# Access Compliance Report

## Public Rights-of-Way

| Intersection ID: 10020377               | Main Street: BALLANTYNE_CORPORATE_PL | Cross Street: N/A                       | Location: SW           |
| ADA ID: 3AD4D7478B6E                    | Ramp Type: Perp                      | Initial Pass/Fail: Fail                 | Overall Compliance: No |

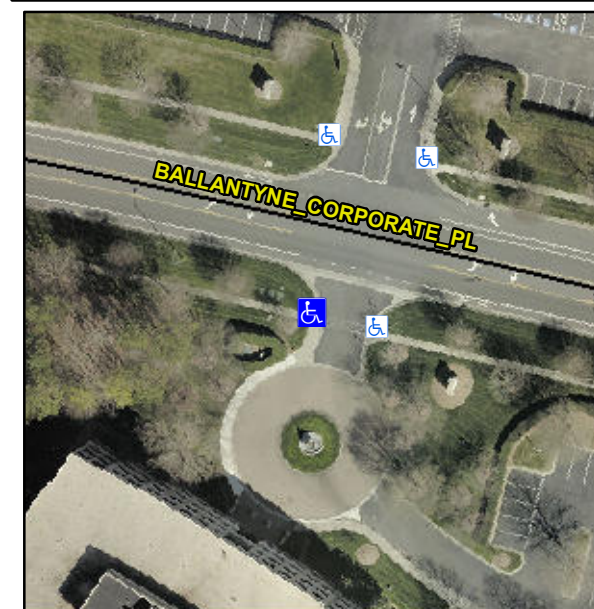
**Not Found, R304.5.1, R304.5.3**

| Compliance | Description           | Data  | Compliance | Description                 | Data |
|------------|-----------------------|-------|------------|-----------------------------|------|
| N/A        | Ramp Length (in)      | 58.0  | Yes        | Ramp Slope (%)              | 6.3  |
| No         | Ramp Width (in)       | 46.0  | No         | Ramp XSlope (%)             | 12.0 |

**Remove & Replace Entire Ramp.**
